Notice of Preparation (NOP) and Responses to the NOP

**NOTICE OF PREPARATION OF A DRAFT PROGRAM
ENVIRONMENTAL IMPACT REPORT FOR THE DIRIDON STATION AREA PLAN**

re: Draft Program EIR for the Diridon Station Area Plan -- File No. PP09-163

Fig. 1 –Park at Montgomery/Autumn

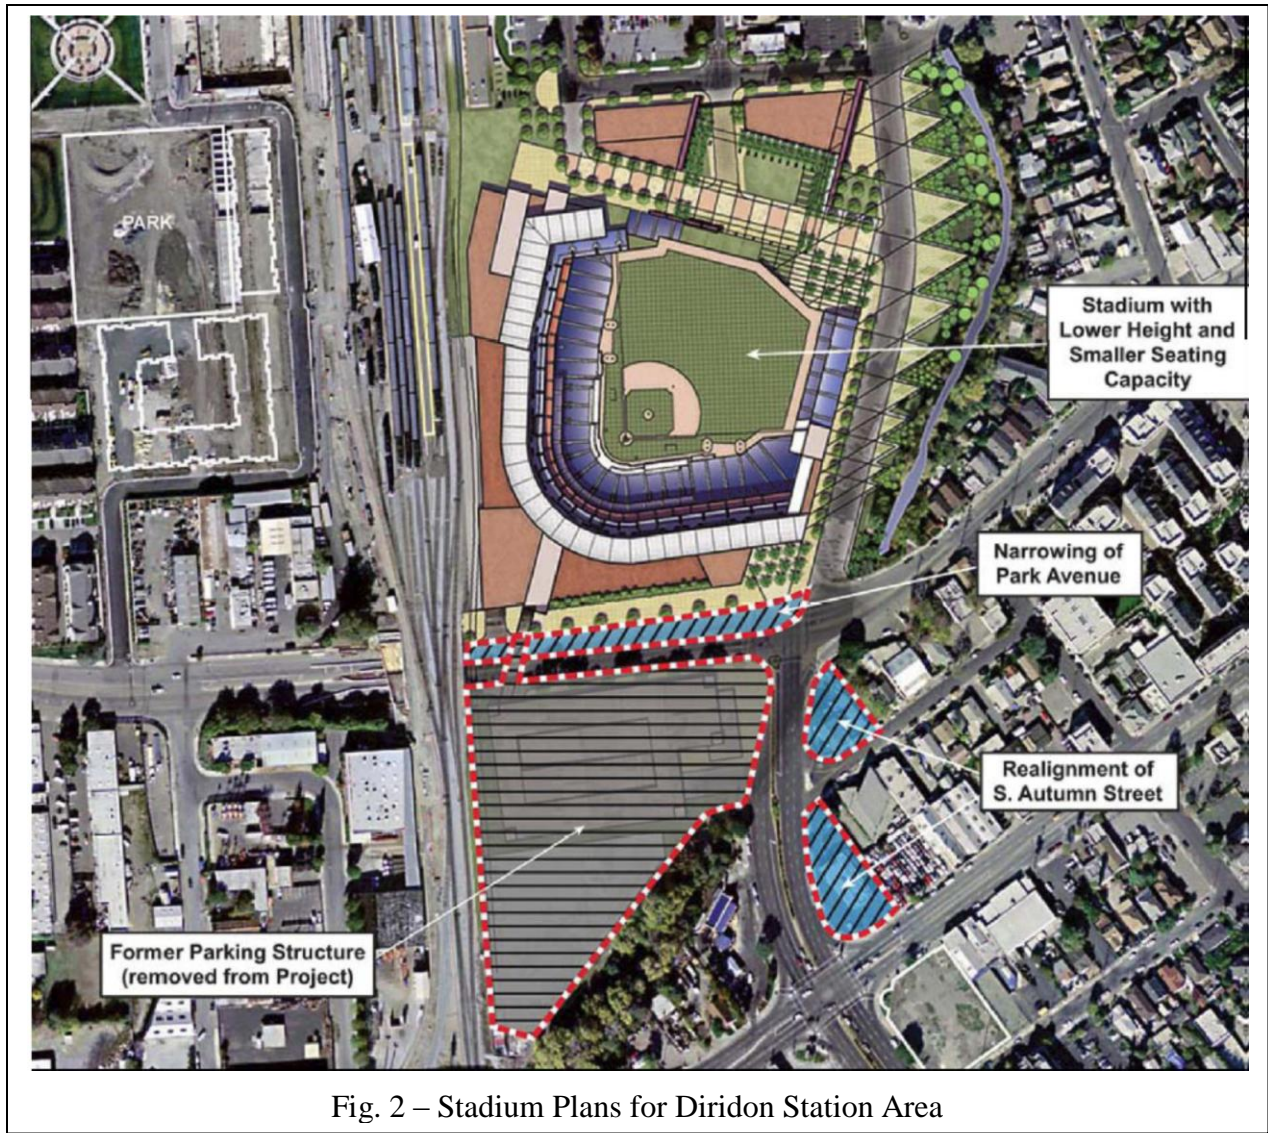
Figure 1 shows the current condition of the Los Gatos at the southern portion of the Project Area: the creek is routed through a culvert under the intersection of Montgomery/Autumn and Park. (I-280 is off the bottom of the graphic, Diridon Station and the proposed stadium are off the top, downtown is to the right.)

The point of these charts is to show that it appears quite feasible to recreate a natural stream channel for the Los Gatos Creek. It will cost money: I would recommend that it be a part of the stadium construction, part of the supporting infrastructure – to be done when the intersection is reconfigured for the street realignments. If the stadium is not built, this could be part of whatever major project does get constructed on the stadium site.

Fig. 3 – Possible Day-Lighted Creek Channel Alignment

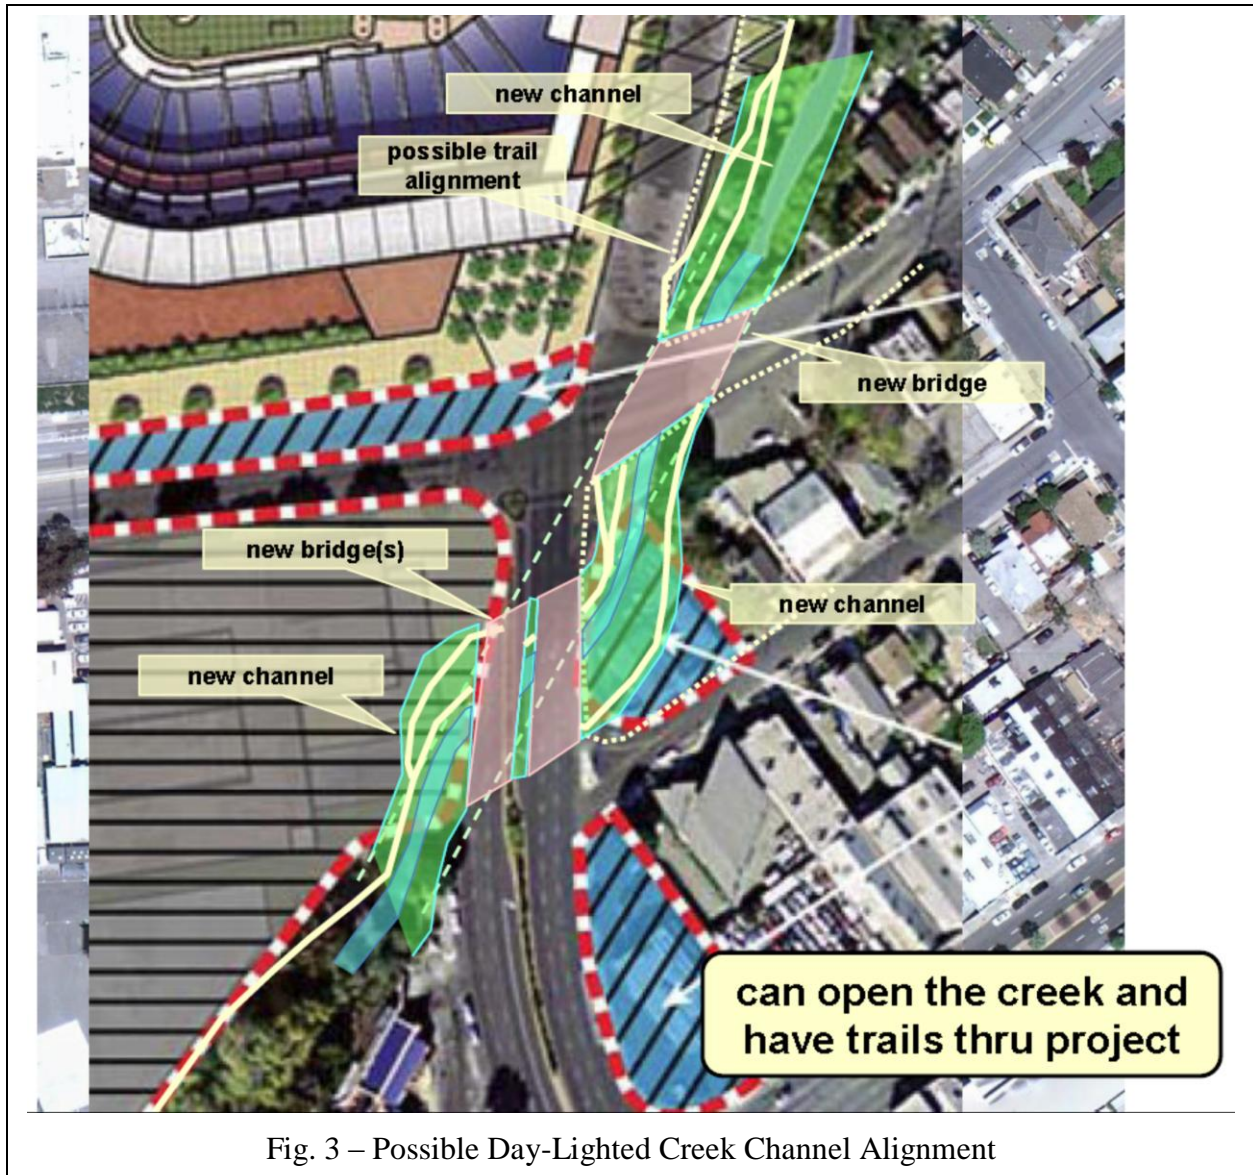
Figure 3 shows a possible alignment of a day-lighted Los Gatos Creek: the green represents the restored creek channel, the blue the stream itself, and the yellow lines show possible trail alignments. The channel utilizes land that is to be acquired for the planned street realignment (the blue areas surrounded by red/white dashed lines), and it presumes that this intersection will be reconfigured according to the new City policy to remove the non-stop right-turn ramps.

The reason for writing this letter is that I want to see the environmental impacts of such a stream day-lighting be analyzed as part of the Diridon Station Area Plan EIR. There are sure to be positive and negative impacts:

Fig. 4 – Northern End of the Los Gatos Creek Culvert

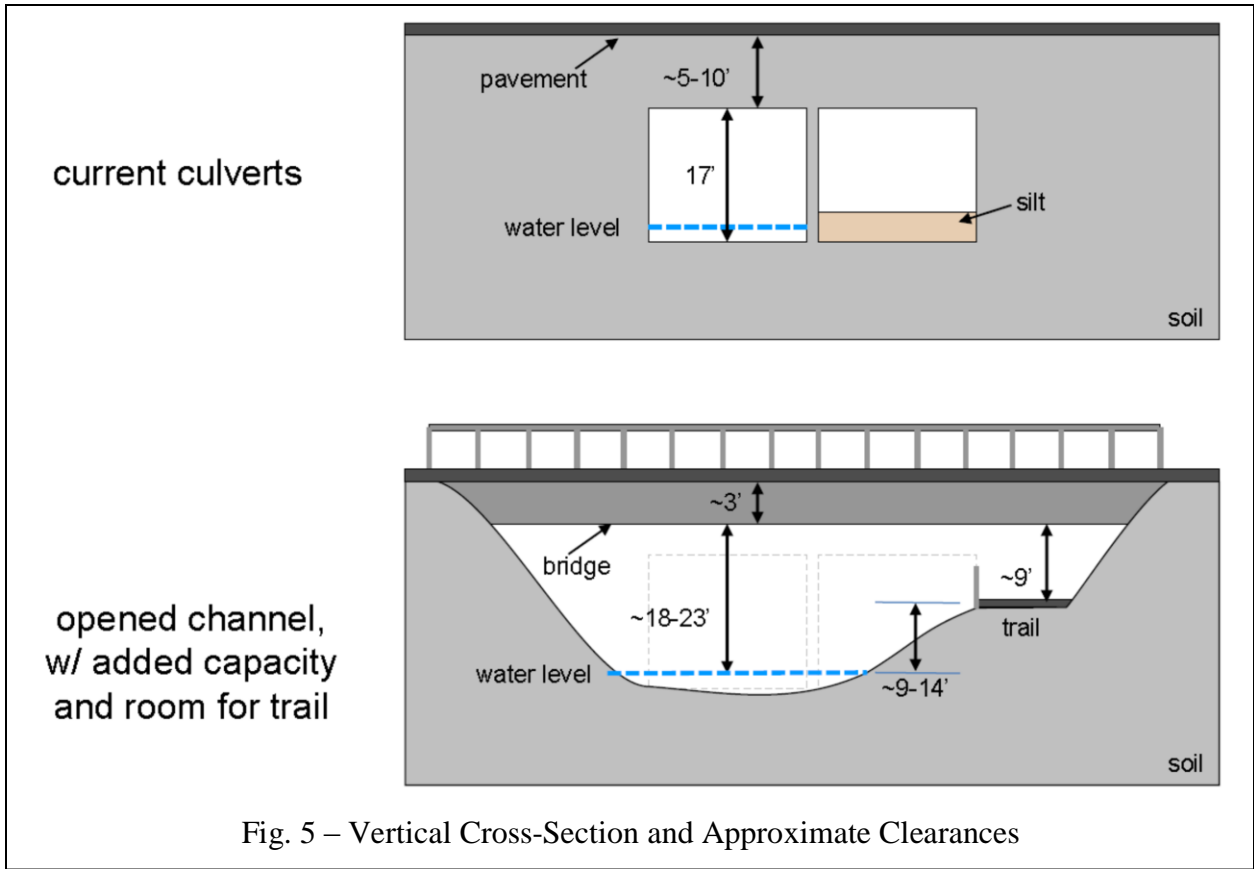
Figure 4 is a photo of the northern end of the creek culvert. (The culvert dimensions are from a study for the Diridon area.)
